## Natural Path Urban Forestry Consultants

**Subject:** Review of Proposed Tree Protection Plan – Babcock Place Development

The following narrative is a review of a Babcock Place Tree Protection Plan Landscape Plan Assessment dated January 16, 2018 and submitted by Howard Gaffin. As a preliminary matter, I am pleased to see that based on the Developer's current proposed plans, the setbacks allow for the potential of proper tree protection for many of the trees of which the abutters were initially concerned. There are however, some remaining issues which must be addressed, as I have outlined below.

### EXISTING CONDITIONS SURVEY 117-123 STEDMAN STREET BROOKLINE, MASS.

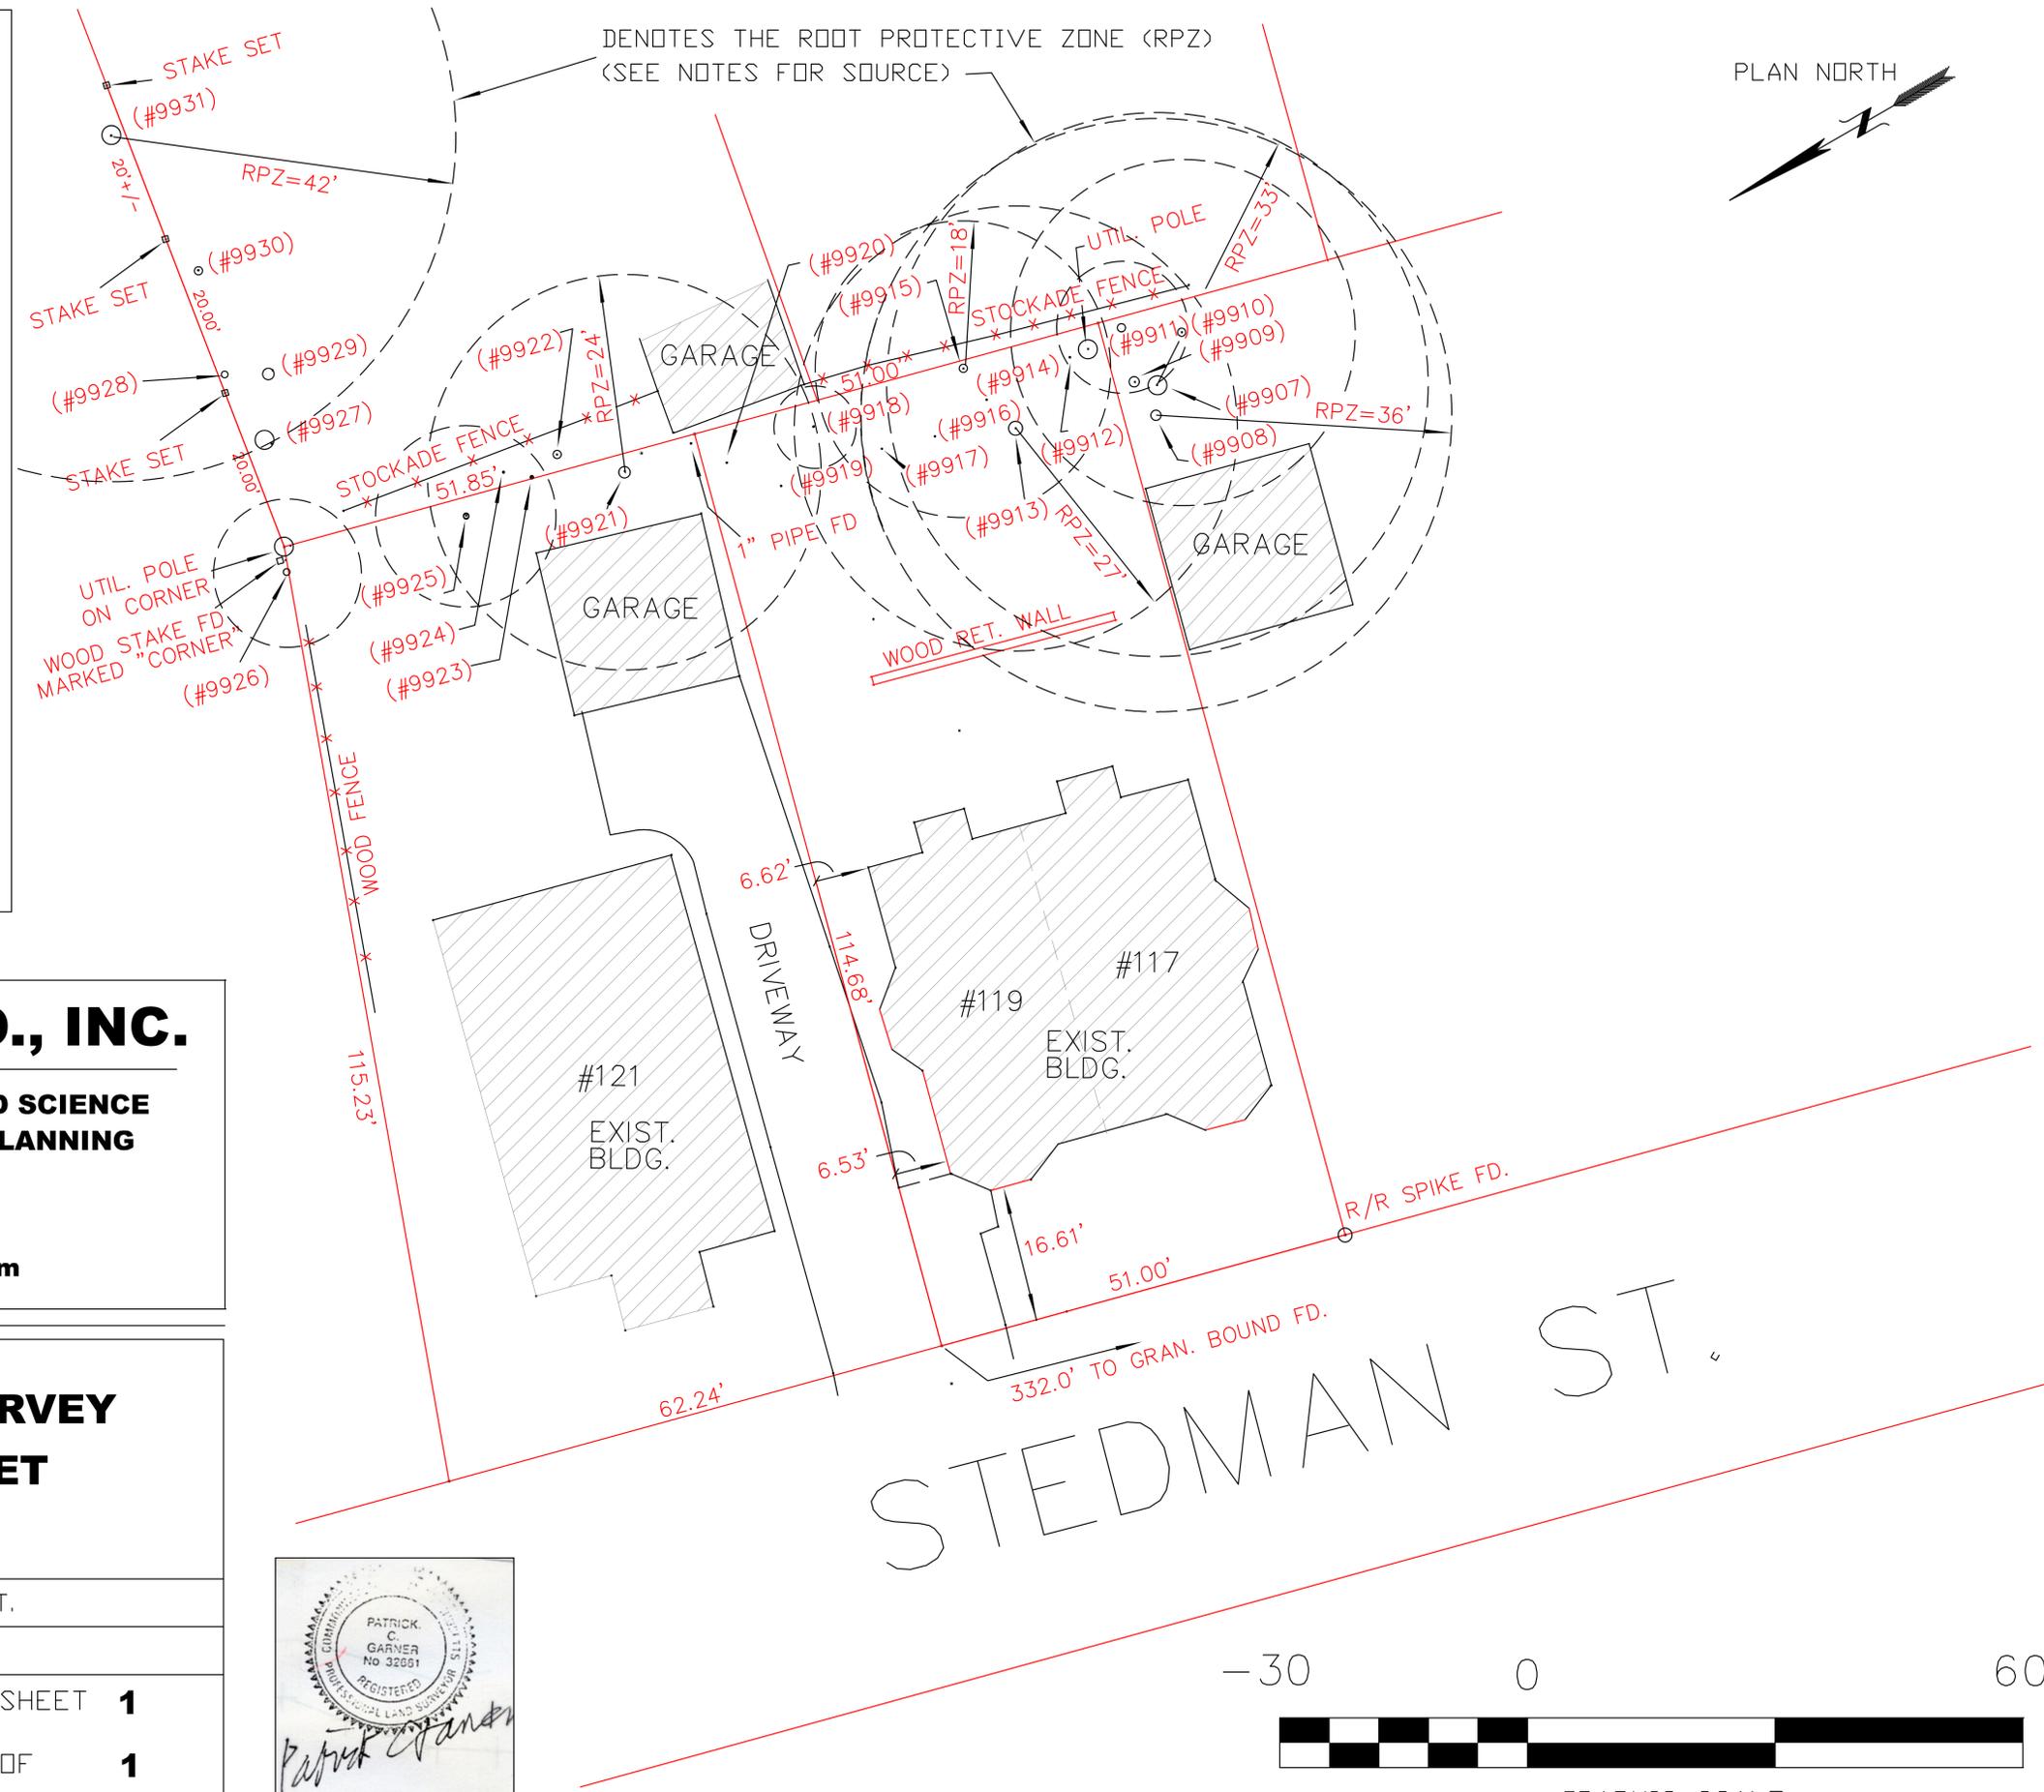
1. Number of Trees – Mr. Gaffin incorrectly identifies the number of trees on abutting properties that can potentially be affected by the proposed development. He identifies five, but fails to address all of the trees highlighted by the abutters, one of which remains at a particular high risk of damage from construction activities. Specifically, Tree 9931 has a RPZ of 42 feet, and is located just 1.5 feet off the property line. Also of concern is Tree 9908 which has a RPZ of 36 feet and is located 12.6 feet from the property line. Based on the current site plans, I have revised Table 1 from my prior reports (below) to include only the trees for which I have the greatest outstanding concerns. I have also included a column providing the distance of each tree to the property line.

4. Root Excavation – As was also noted in my initial report, a tree’s current form and condition are a function of its adaption to the site in which it has always existed. Mr. Gaffin observed that in areas 2 and 3 (as designated by Mr. Gaffin) there are only “a few large roots that would likely extend into the asphalt” downplaying the need to take measures to protect these trees (“following industry guidelines will be more than sufficient.”). However, the minimal amount of roots identified in the excavation holes actually underscores the importance of protecting these roots. This observation suggests that a more expansive TPZ is needed rather than the bare minimum that Mr. Gaffin suggests, and likely greater than the mid-range estimate I relied upon. Further, it should be noted that Mr. Gaffin failed to perform any excavation in the vicinity of Tree 9931, the 28” tree with a RPZ that extends well into the footprint of the building.
